Power Equipment

Code: CC-277

Subject: Front wheels rubbing the side panels while turning on slopes or hills.

Models: 2160, 2165 and 2185.

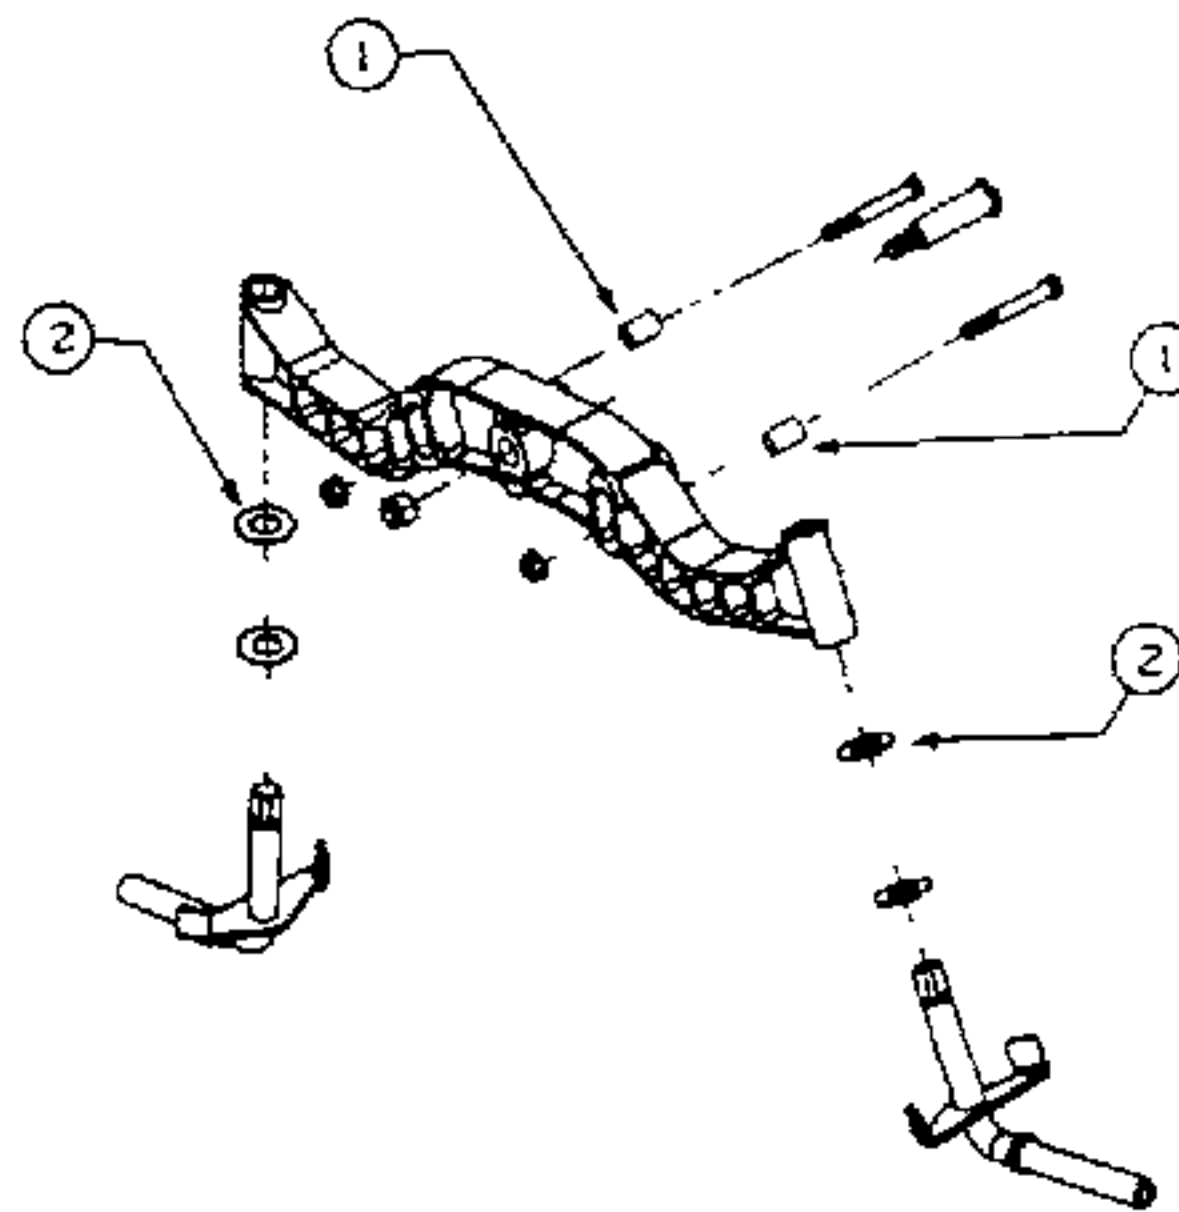
Problem: Incorrect tolerances in the steering geometry.

Solution: Order the parts listed and install following the instructions provided.

Instructions: Check for the proper 1/8th inch toe-in from rim to rim at the front of the tractor. Install the spacers (reference number 1) over the limiter bolts for the front pivot axle as shown. Install one flat washer (reference number 2) between each steering knuckle and the pivot axle. NOTE : DO NOT REMOVE EXISTING WASHERS FROM THE STEERING KNUCKLES. The total thickness of both washers raises the front of the tractor to allow proper clearance. Submit a warranty claim for 1 hr labor and the cost of the parts.
